Bob Thompson
South Lamar Neighborhood Association
December 6, 2012

Subj: Questions on Drainage/Floodwater Detention for Lightsey Tract
 Date: 11/30/2012 11:58:24 P.M. Central Standard Time
 From: JRT3308@aol.com
 To: ryan@pswrealestate.com
 CC: nancy.maclaine@gmail.com

Drainage/Flood Water Detention Questions:

EXISTING DRAINAGE AREA MAP

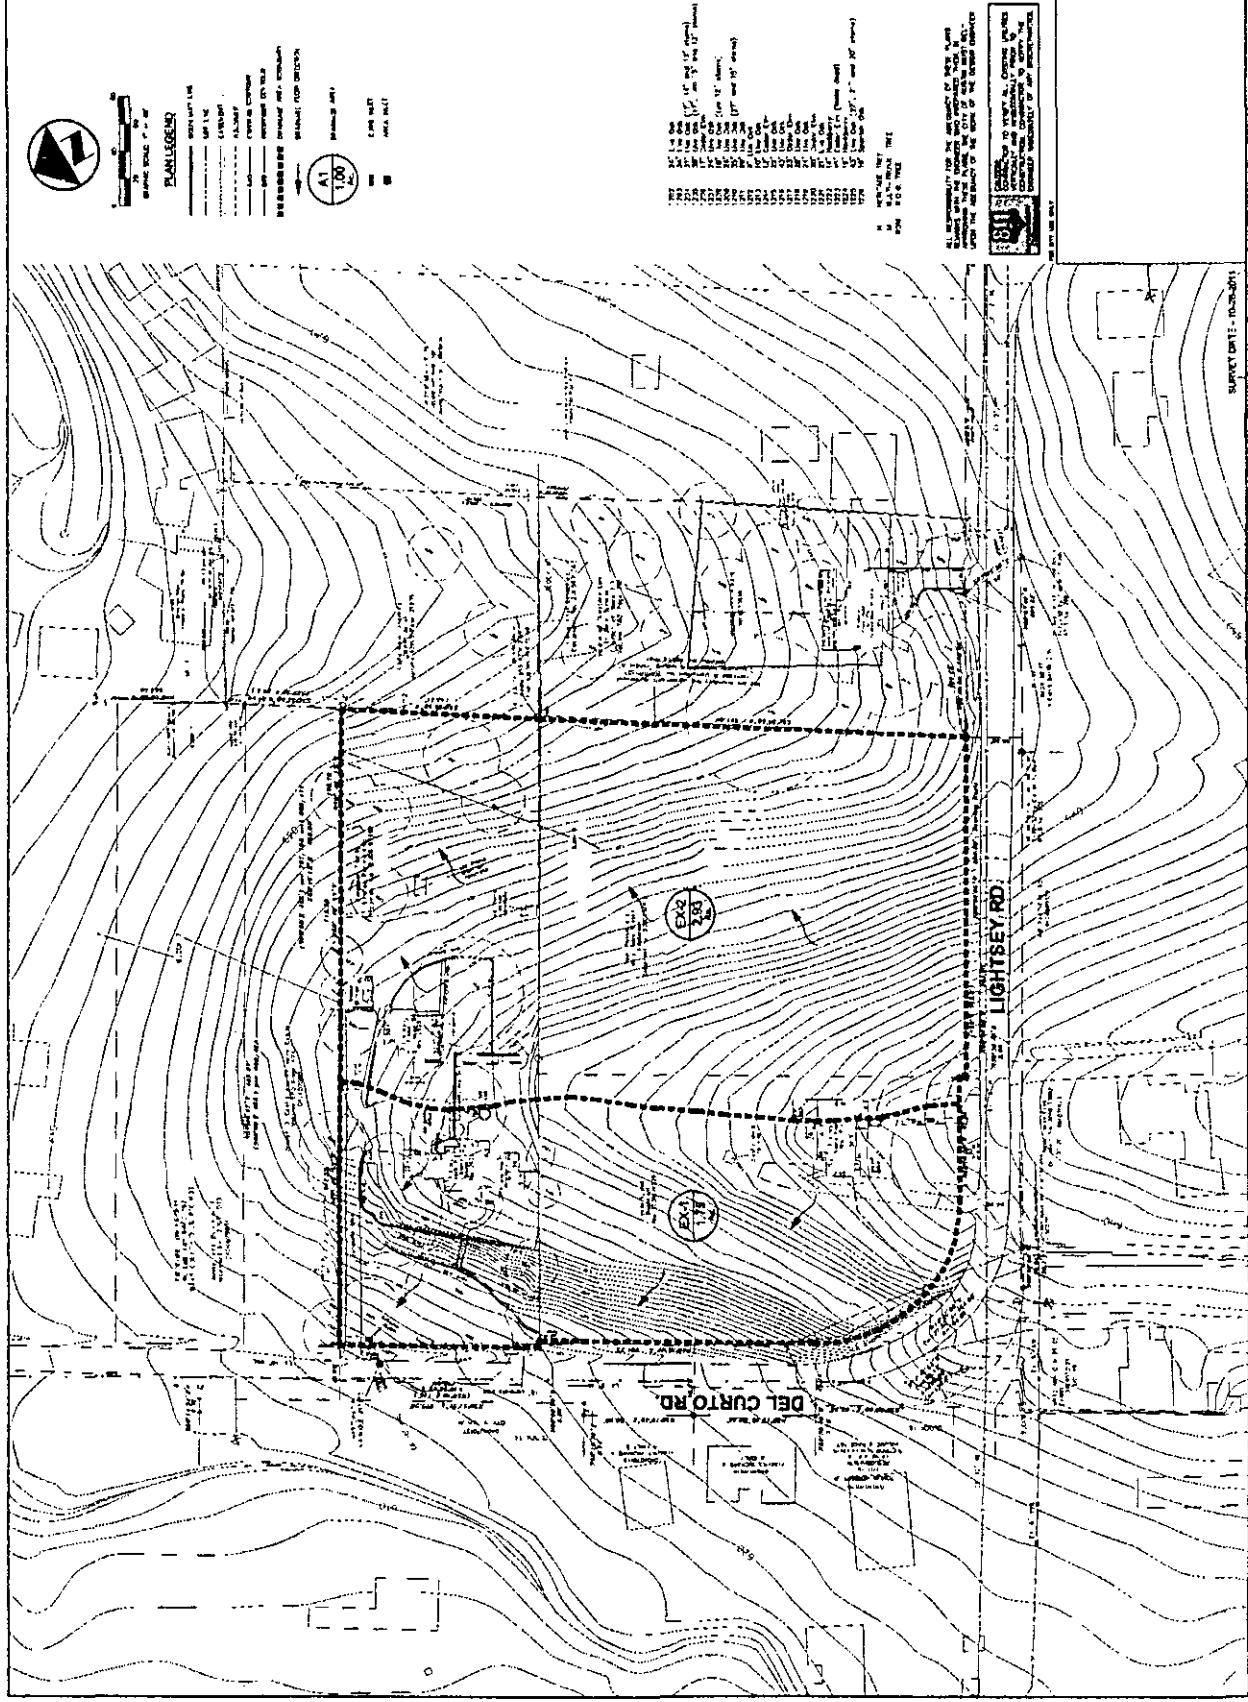
- (3) The illustrated pond appears positioned at surface elevations between about 625 ft. at the NW corner and 641 ft. at the SE corner, as it is to be constructed on a steep hillside. Has someone reviewed the engineering design of the pond's construction?

- (4) How is the intercepted floodwater to be conveyed to the pond, taking into account the topographic elevations of the tract? For example, there is a relatively high ridge running NS through the tract, about one-third of the way across the tract from the W edge. This ridge has elevation ranging from a high of 660 ft. at the southern (Lightsey) end, and the ridge elevation does not fall below 641 ft. until very near the N end of the tract, beyond the existing constructed walls. To illustrate the challenge, the SE quadrant of the tract, apparently designated as drainage area A-6, will send a lot of floodwater runoff to the ENE where it will naturally tend to exit the tract along the SE boundary at elevations of 622 ft. to 632 ft. or so. If this flood runoff water is collected at these elevations, how is it to be conveyed west beyond the ridge that may be some 20-30 feet higher, before being brought back down to the pond elevation? Will there be pumps installed to raise the water? Will there be deeply excavated pipes to convey the water deep beneath the ridge line? Will there be pipes to convey the water N along the E edge of the tract, until lower elevations are reached and the water may more easily be diverted to the W (even then having to combat increasing ground elevations to the W)?

- As a second illustration of the difficulties, floodwater in the NE portion of the tract, in drainage area A-4, will tend to drain toward the NE corner of the tract where it might exit at elevations of around 615 feet or so, if not collected. If it is somehow collected, how is it to be conveyed uphill past the central ridge line? Again, will there be pumps or deeply excavated piping?

PROPOSED DRAINAGE AREA MAP
LIGHTSEY OAKS SUBDIVISION

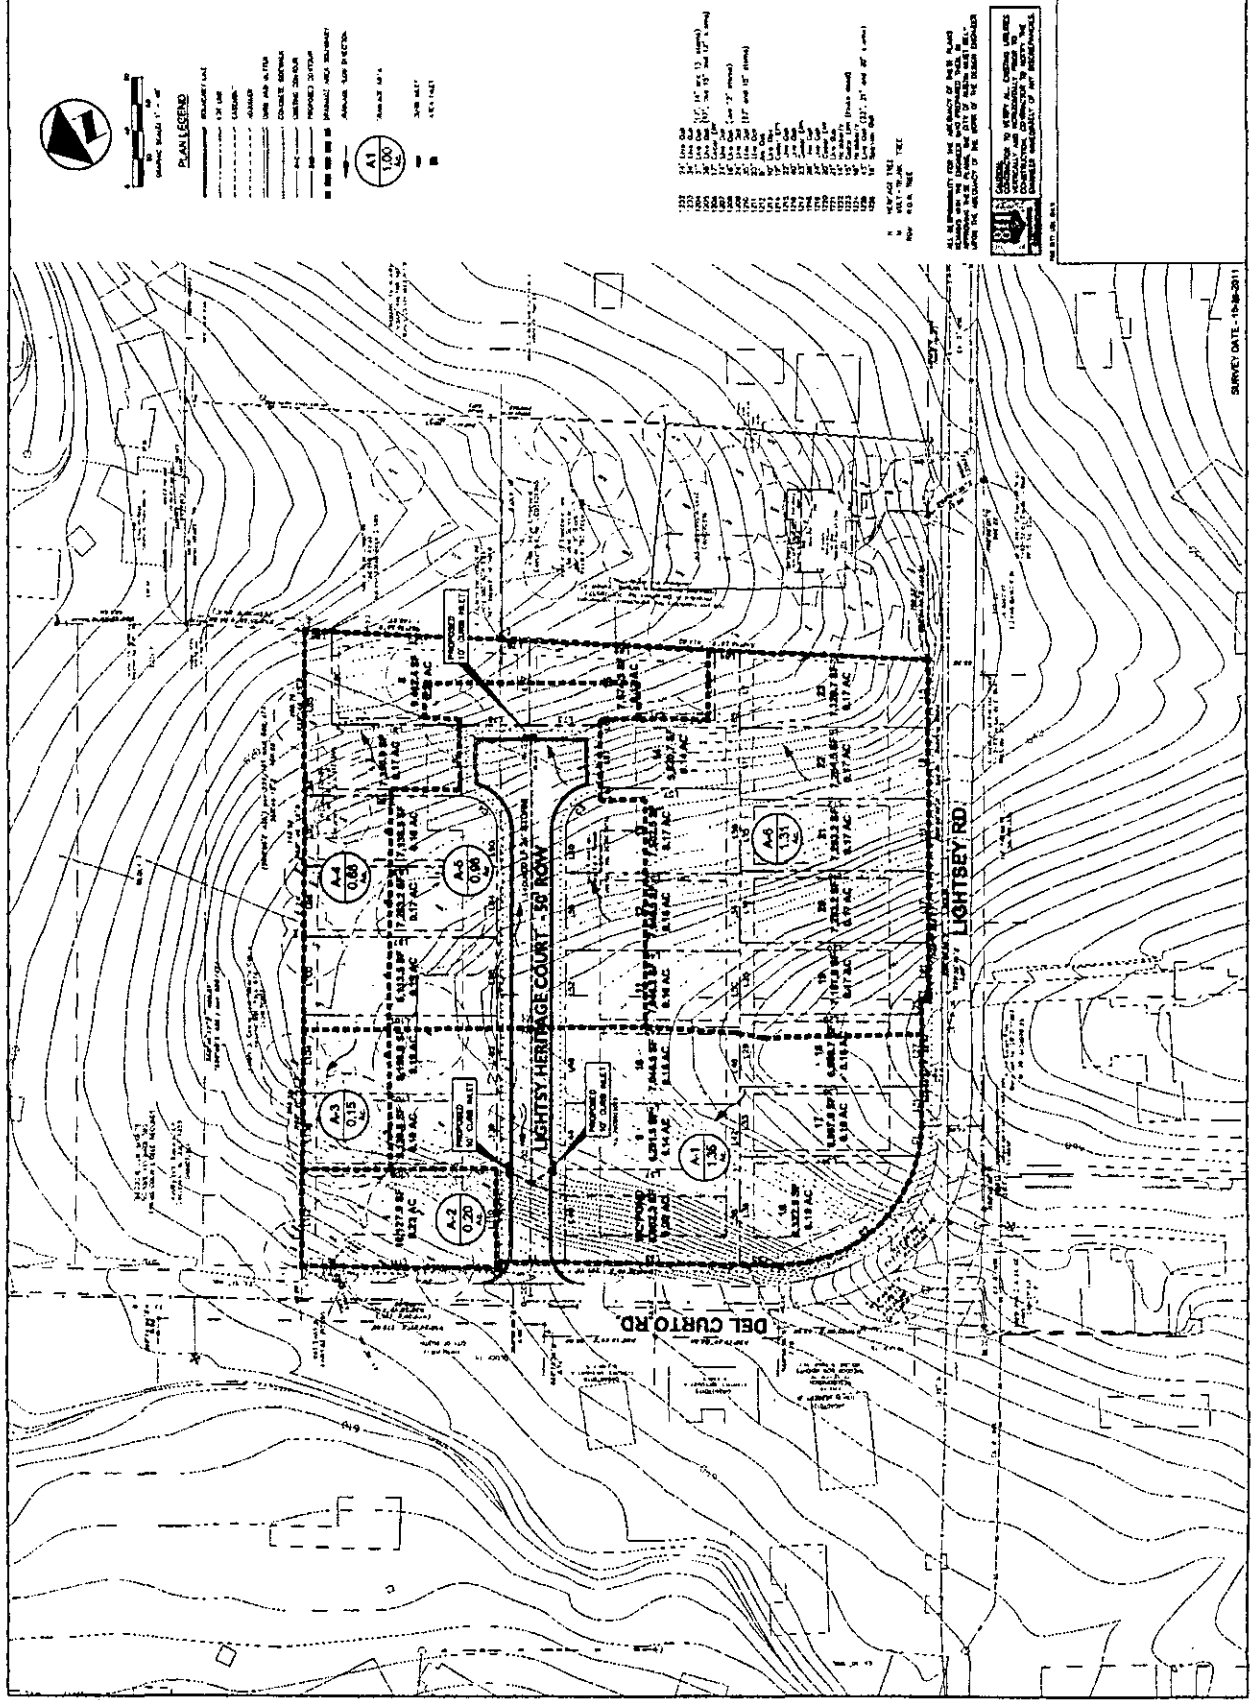
- (1) How much water detention capability (cu.ft.) is provided, and how was this amount determined? Is the pond shown near the W boundary, with 8662 SF, the only floodwater detention pond, and how deep is it?

- (2) How will the flood runoff water be intercepted before it leaves the tract along the W, N, and E boundaries? (Otherwise, what is the assurance that the provisions of Section 1.2.2 of the Drainage Policy will be obeyed?)

- (5) If the construction plan does envision massive excavations of 20 feet or more on the tract, have there been engineering evaluations and environmental evaluations of these plans?

- (6) Will the developer be permitted to discharge water from the detention pond during a flood event? If so, how much discharge will be allowed, and where will the water be discharged?
